Pentium® II Xeon™ Processor Specification Update

Release Date: June 1999

Order Number: 243776-013

Figure 1. An Example of Microcontroller Driven Thermal Management

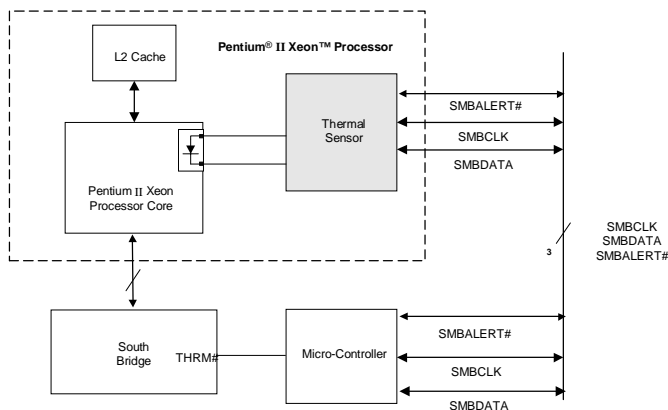
D30. Thermal Sensor May Assert SMBALERT# Incorrectly

PROBLEM: The Pentium II Xeon processor has a thermal sensor that monitors the processor core's temperature. The thermal sensor asserts SMBALERT# if the processor temperature exceeds the temperature limits set in the Alarm Threshold Registers (T_{HIGH} , T_{LOW}). It also sets the corresponding Status Register bits to identify the cause of the interrupt. Figure 1 gives one example of the how the SMBALERT# signal could be used in a system.

Under the conditions described below, the thermal sensor incorrectly generates the SMBALERT# interrupt. *All* of the following conditions must be met to trigger a false interrupt:

WORKAROUND: Three different (mutually exclusive) workarounds are possible:

1. Before servicing an interrupt from the thermal sensor, read and compare the processor thermal reading with the threshold limits (T_{HIGH} or T_{LOW}). Figures 2 and 3 provide basic flowcharts for the implementation of this workaround in an interrupt driven system.
2. If the firmware implemented polls the Status Register only, then before taking any action, re-read the temperature register and do a comparison with the alarm threshold limits (T_{HIGH} or T_{LOW}) to determine if the value is actually still within the temperature window.
3. Use a temperature polling scheme to monitor the processor temperature.
